UNITED STATES PATENT AND TRADEMARK OFFICE

APPLICATION NO.	FILING DATE	FIRST NAMED INVENTOR	ATTORNEY DOCKET NO.	CONFIRMATION NO.
10/729,086	12/05/2003	Fred H. Burbank	R0367-02501	8823

Office Action Summary

DETAILED ACTION

FIG. -3

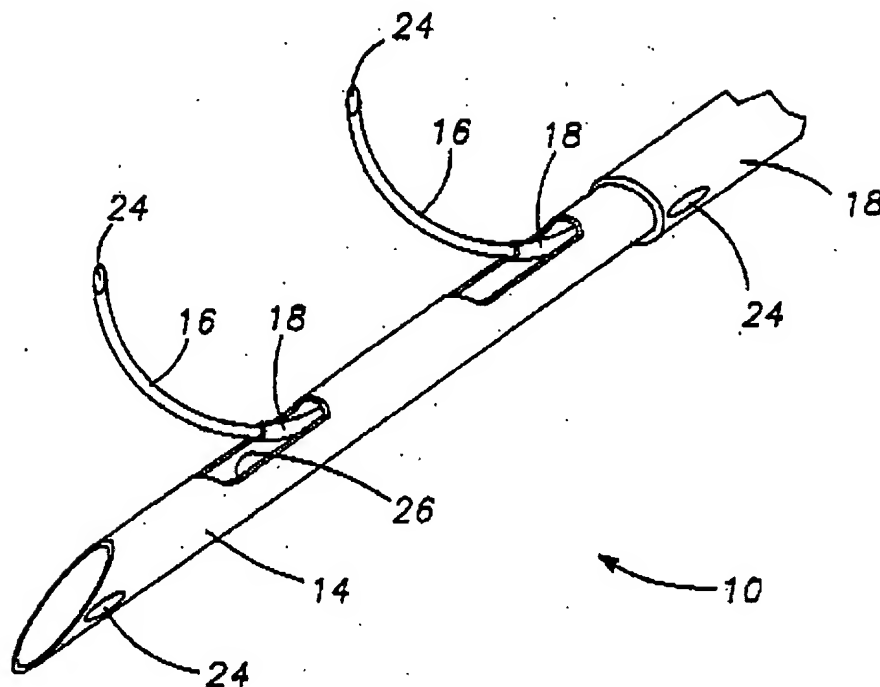
In regard to claims 37-39, Gough et al. disclose the features of the Applicant's invention as described above including a node accessing and anchoring device (10) comprising an elongated shaft (18) having an inner lumen, a distal end (14), a proximal end, a longitudinal axis, a radially

extending anchoring element (16) and a tissue cutting member located at the distal end of the shaft as shown in Fig. 3.

The Gough et al. device includes at least one anchoring element having a retracted configuration and an extended configuration (col.7; col. 8, lines 1-54). Although Gough et al. disclose having sensors other than thermal sensors as a detector located within the inner lumen of the elongated shaft, Gough et al. do not disclose the device having a radiation detector to detect radioactive material from the lesion site. Ritchart et al. disclose a device for collection of soft tissue. The
